MANATEE COUNTY

SUBJECT: IFB #11-0579-OV / Downtown Bradenton Transit Station
Location: 601 13th Street West, Bradenton, FL
(Manatee County)

ADDENDUM #2

March 15, 2011
IFB #11-0579-OV / Downtown Bradenton Transit Station
Location: 601 13th Street West, Bradenton, FL (Manatee County)
Addendum #2
Page 2

SLAT FRAME TOP CONNECTION
 SCALE: 1 1/2" = 1'-0"

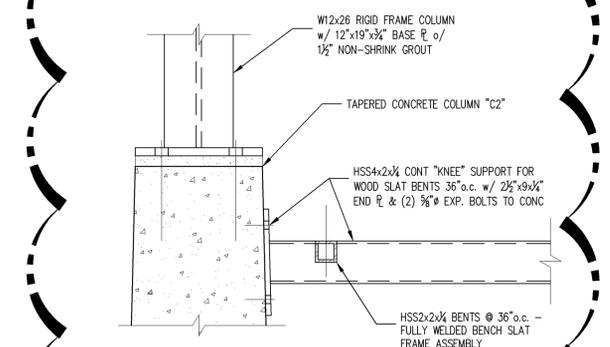
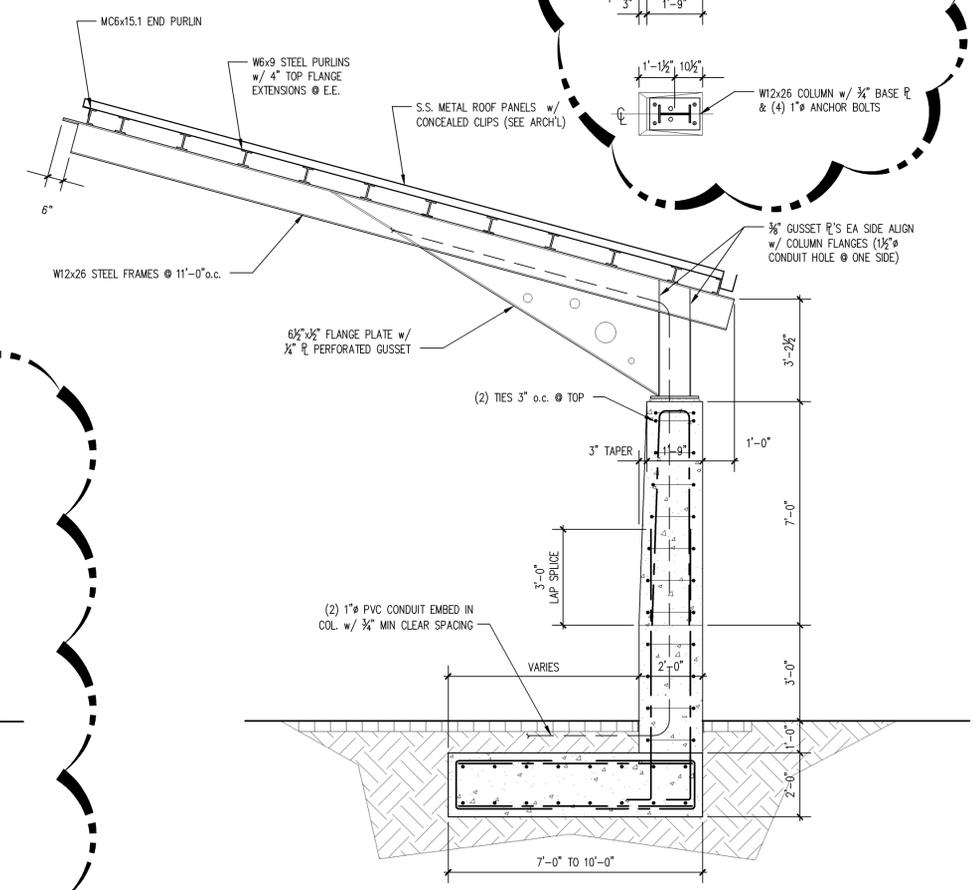
Question 34: 10/A802 Bench Detail calls for 2"x 2" Steel Tube Framing 4 per bench. 1/A712 Section Thru Bus Canopy calls for 2"x 2" Steel Tube Framing 3 per bench. 4/A201 Bench Enlarged Plan shows four (4 ea.) and says "Tube Steel See Structural Drawings", but there does not appear to be any details for this typical condition on the Structural Drawings. Please advise.

Question 51: Provide a detail for the 2" X 2" tube steel support system for the cedar slats, since they are not shown on the structural drawings per the notes on Sheet A201 and A601. Also provide details for attaching the tube steel to the concrete columns and steel roof structure.

Question 52: Drawing A201, Detail 4, bench Enlarged Plan indicates tube steel is required to attach the wood slats. The detail refers you to the structural drawings for the tubing. However, the structural drawings do not show the steel tubing. Please provide tubing size and attachment details.

Answer: Each bench shall have 4 steel tube framing elements. Please see revised structural drawings for connections (S2.1 B&C). Drawing 1/A712 should read 4 instead of 3 per bench.

Answer: See details B & C/S-2.1.

Answer: See details B & C/S-2.1.

ART WALL SECTION A-A
SCALE: 3/8" = 1'-0"

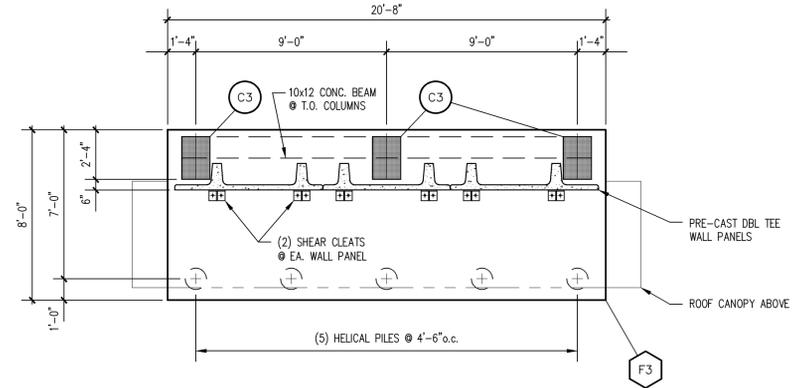
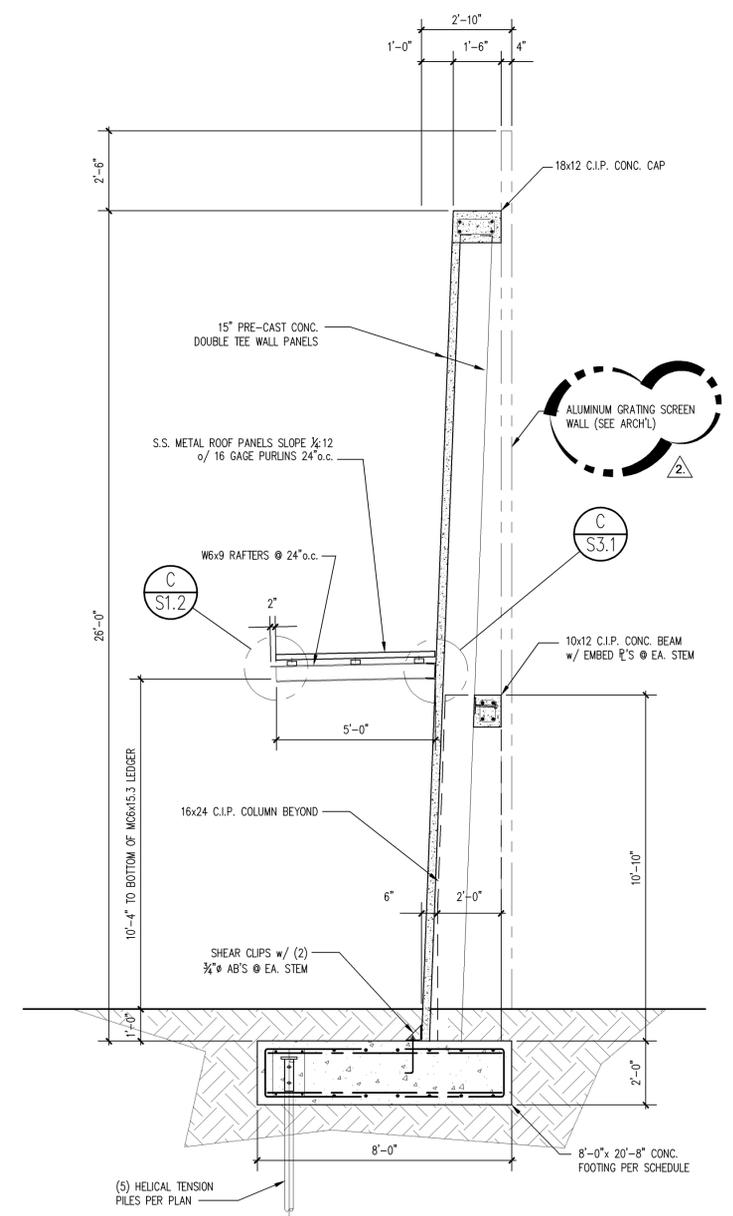
Question 20: Sheet s-3.1 art wall section a-a calls for steel grating screen. Sheet a601,a602,spec 06 20 00-3 call for aluminum.

Answer: Structural Drawing has been revised to read Aluminum Grating. Please see revised S-3.1 for more info.

S. PERGOLA BEAM CONNECTION
 SCALE: 1 1/2" = 1'-0"

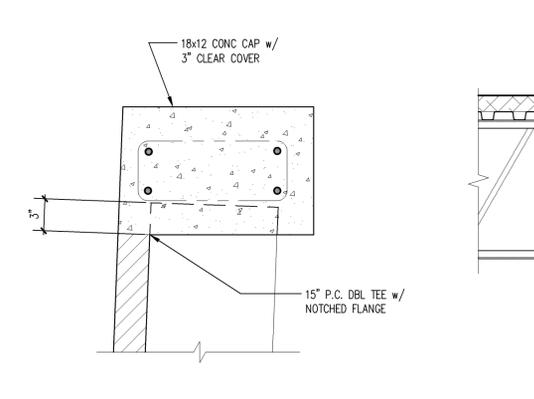
Question 50: Provide connection details for the south pergola to the precast at the art wall, since they are not shown on Sheet S-4.1.

Answer: See detail A/S-5.1.

ART WALL CAP DETAIL
 SCALE: 1 1/2" = 1'-0"

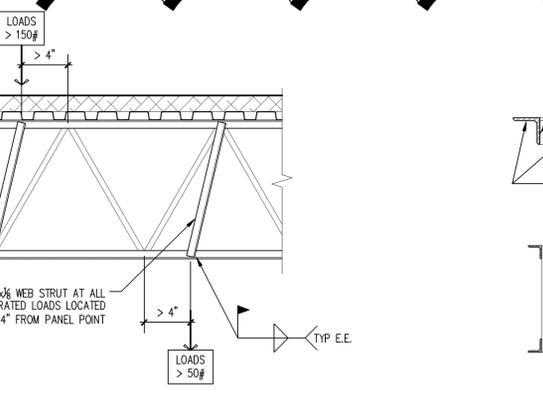
Question 56: A-A/S3.1 shows an 18 x 12 C.I. P. Conc. Cap on top of the Double T Art Wall. Is there a connection of the T to the Concrete Beam (clip angles or an embedment depth of the T into the Concrete Beam)?

Answer: Stems of the pre-cast double tees shall be embedded 3" into concrete cap, see detail B/S-5.1.

JOIST REINFORCING @ POINT LOADS
 SCALE: 3/4" = 1'-0"

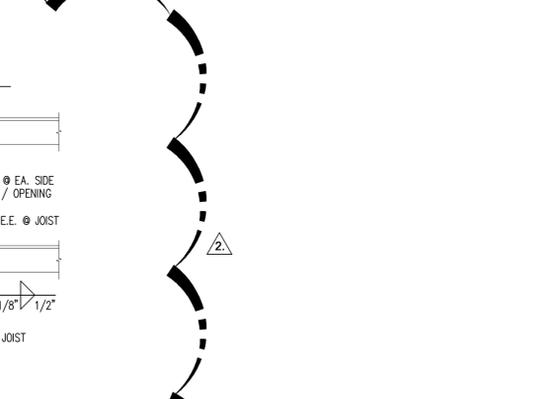
Question 57: Plan Sheet S-1.1: Low roof framing plan has no details for the exhaust fan support steel. Was this overlooked or not required?

Answer: See details C & D/S-5.1 for joist reinforcing and roof support at roof mounted equipment and and openings greater than 6" in the metal roof deck.
